**Re: Wastebed B/Harbor Brook Consent Order #D-7-0001-00-02 Site #734075
Revised Final Feasibility Study Report**

This letter provides an electronic copy of the Revised Final Wastebed B/Harbor Brook Feasibility Study Report prepared by OBG. Hard copies of the report will be distributed next week. Please contact Jennifer Reymond of OBG at (315) 956-6446 or me if you have any questions or comments.

Figure 12: Wastebed B/Harbor Brook Site Waste Management Area and Groundwater Point of Compliance

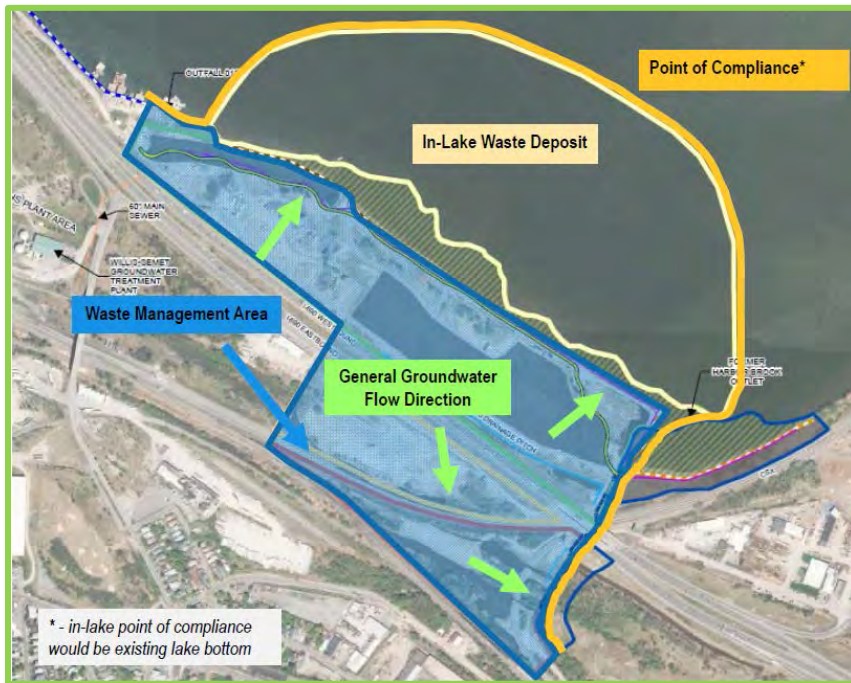
Comment 25: Page 32, Paragraph 4, RAOs for Environmental Protection, Section 3.1.3. It is unclear why the discussion focuses on attainment of human health SCOs to "ascertain acceptable concentrations for a given anticipated site use." The RAO is for protection of biota, yet the means of attaining this protectiveness is achievement of an RAO for the protection of human health. Revision and/or additional clarifying language is recommended.

Response to Comment 26: A figure (in text Figure 12) presenting the boundary of the waste management area and groundwater point of compliance is included in Section 3.1.4.

**IRMs AND
SITE CHANGES**

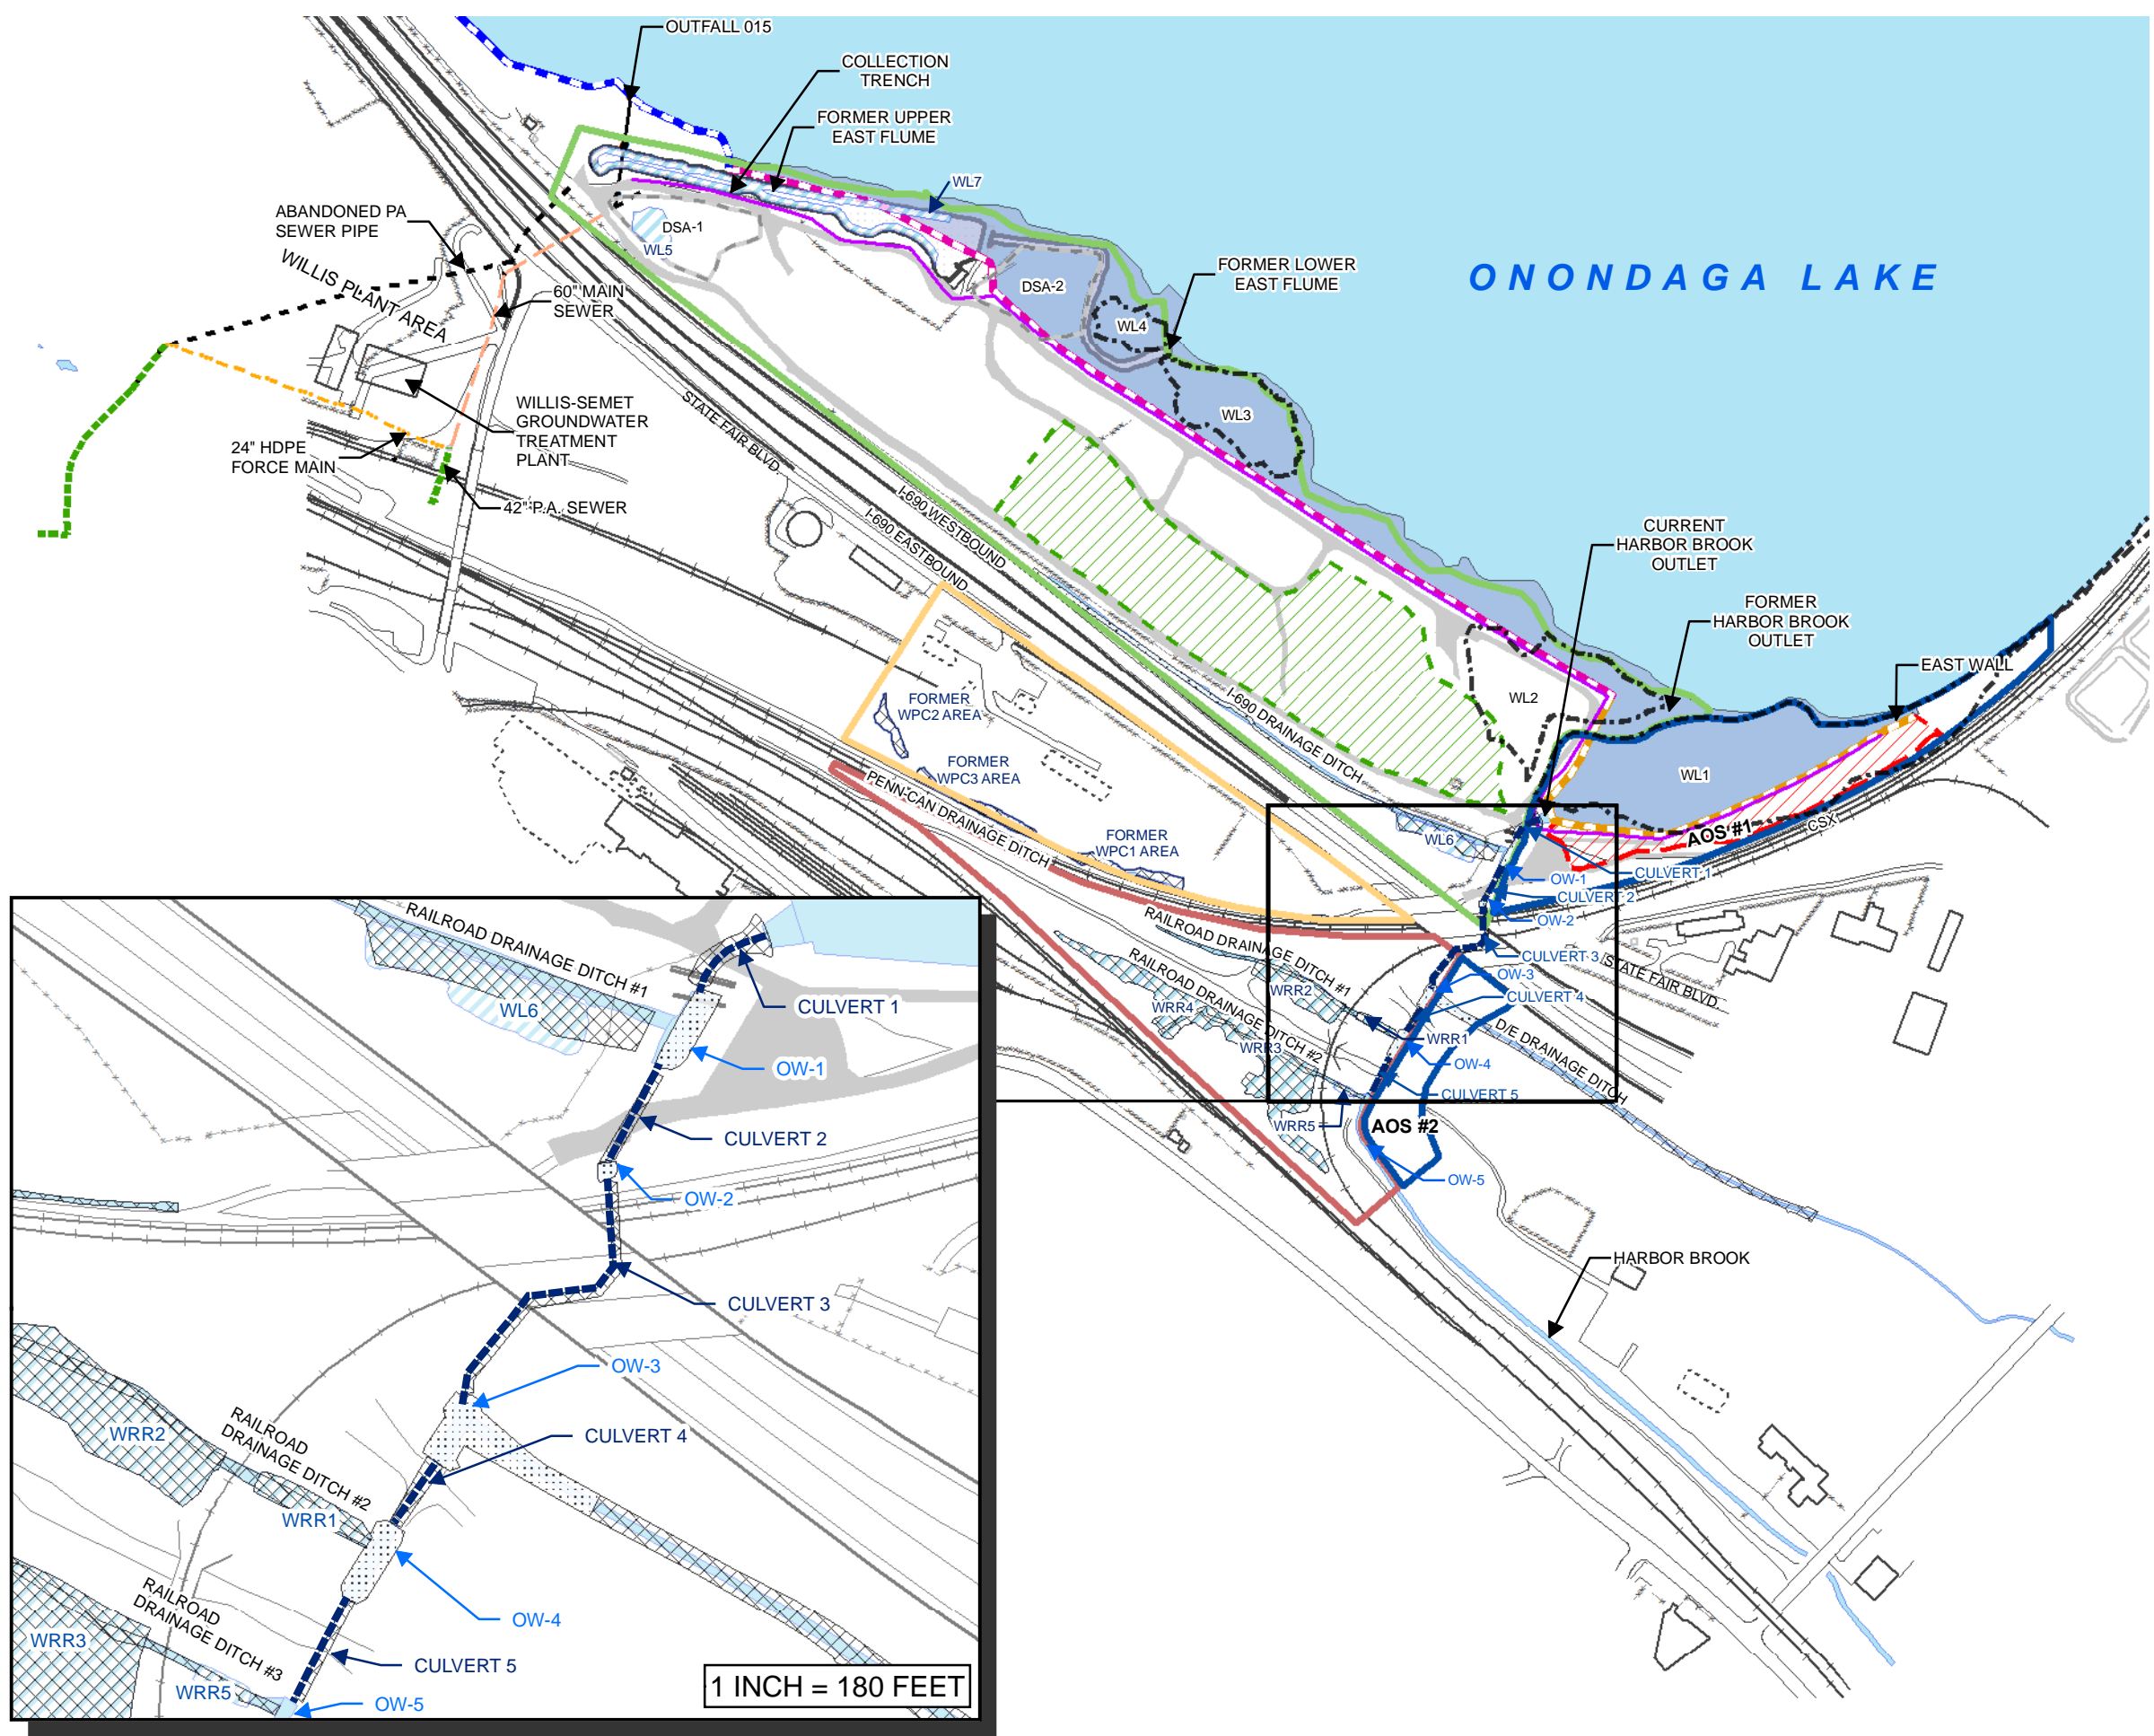
Comment 3. General Comment. A one-acre wetland would be created in the vicinity of wetland WL2 under Alternatives 4 and 5 to compensate for wetlands lost during the East Flume IRM. However, it is not clear from the various figures in the FS what the current conditions are. For example, Wetland WL2 is shown on Figure 1-2, but other figures show no wetlands in the area slated for wetland construction and/or restoration. Consequently, some clarification as to the current and proposed extent of wetlands under these alternatives should be provided.

Response to Comment 3: Revisions to labels and legends in Figures 1-2 and 1-3 have been incorporated to provide clarification between historical wetland areas, Interim Remedial Measure (IRM) impacts to wetlands (*i.e.*, differentiation between pre- and post-IRM construction wetlands), and outboard transitional wetlands now part of Onondaga Lake.
